Interactive comment on “Electricity savings and greenhouse gas emission reductions from global phase-down of hydrofluorocarbons” by Pallav Purohit et al.

Referee 1 (Anonymous)

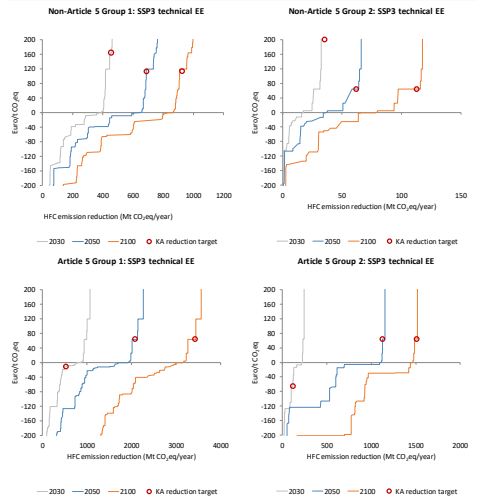
2. The paper contains too many figures; they distract the reader from the main message. Most figures also contain a lot of lines which makes them hard to read and to get the main message out of them. Figure 3: two panels as an example is enough, the rest can be put in the SI. Figure 4 is not needed, since Figure 5 shows the same information in a much clearer way. Figure 6: is this figure needed, if yes, reduce the number of lines. Figure 7 is good and clear. Figure 8 is not readable, too many panels

19. L348: Very useful paragraph. The corresponding figure (3) needs to be simplified (see below). Have the national/regional regulations that are already in place been taken into account here? In the EU for example the phasedown of HFCs is already well underway.

21. L783: Figure 3: Simplify this figure by moving panels to the SI. The message comes much better across with only two panels.

Authors' Response: As suggested, we have improved the font size and split Figure 3 in two parts – Marginal abatement cost curves (MACCs) starting from a pre-Kigali SSP3 baseline consistent with the IEA-WEO17 New Policies scenario and reducing HFC emissions by KA party groups under a) technical energy efficiency improvements in the revised manuscript; and b) economic energy efficiency improvements in the supplementary section (Figure S4).

Authors' Response: As suggested, we have improved the font size and split Figure 3 in two parts – Marginal abatement cost curves (MACCs) starting from a pre-Kigali SSP3 baseline consistent with the IEA-WEO17 New Policies scenario and reducing

HFC emissions by KA party groups under a) technical energy efficiency improvements in the revised manuscript; and b) economic energy efficiency improvements in the supplementary section (Figure S4 of the SI).

Authors' Response: As suggested, we have improved the font size and split Figure 3 in two parts – Marginal abatement cost curves (MACCs) starting from a pre-Kigali SSP3 baseline consistent with the IEA-WEO17 New Policies scenario and reducing HFC emissions by KA party groups under a) technical energy efficiency improvements in the revised manuscript; and b) economic energy efficiency improvements in the supplementary section (Figure S4).

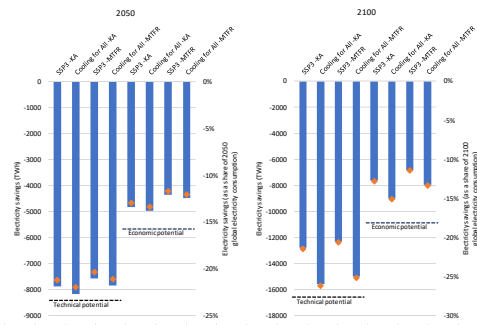
22. L790: Figure 4 shows negative numbers for savings. I think this is confusing. Or 'savings' or negative/reduced electricity use. In also Figure 5 where positive savings are shown.

In the revised version of the manuscript, Figure 4 on “Technical and economic electricity saving (TWh) potentials in HFC reduction scenarios (KA and MTR) relative pre-KA baselines (SSP3 and Cooling for All)” is deleted as suggested by the reviewer.

Authors' Response: We have replaced "savings", which indeed was incorrect if expressed in negative numbers, to "Potentials for changes in annual electricity consump-

tion”.

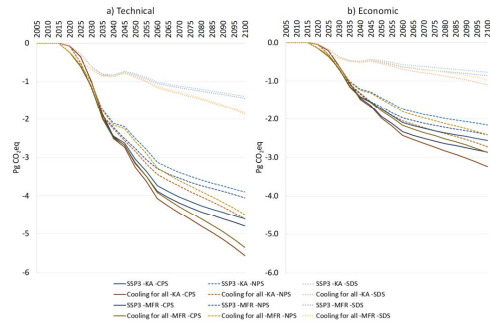
23. L800: Same as in figure 4. Confusing to show negative emission reductions.

Authors' Response: Same here, reductions changed to “Changes in annual GHG emissions”. Thanks for pointing this out.

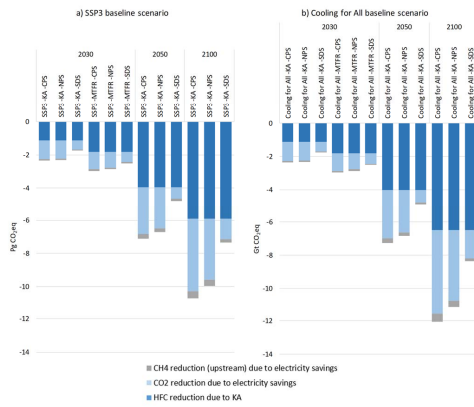
24. L805: Same as figure 4 and 5 L810: Figure 8: Very unclear: too many panels and too small numbers. This figure has to be improved.

As suggested, we have improved the font size and readability of Figure 6 in the revised version of the manuscript.

Figure 8: Impacts on air pollutant emissions due to electricity savings associated with alternative HFC phase-down pathways.

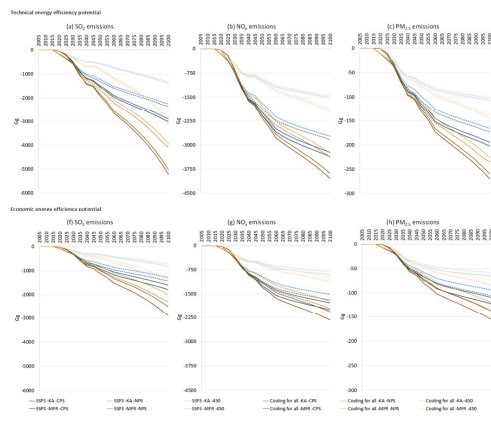
and too many lines. Replace with one clear figure and move the rest to the SI. Some figures also need larger legend.

Once again, we have improved the font size and split Figure 8 in two parts – a) Impacts on air pollutant emissions due to electricity savings are presented in the revised manuscript whereas the b) Impacts on BC/OC emissions due to electricity savings are presented in the supplementary section (Figure S8).

Authors' Response: As suggested, we have improved the font size and split Figure 8 in two parts: Impact on a) air pollutant emissions (see: Figure 8 of the revised manuscript), and b) BC/OC emissions (Figure S8 of the supplementary section) due to electricity savings associated with alternative HFC phase-down paths.
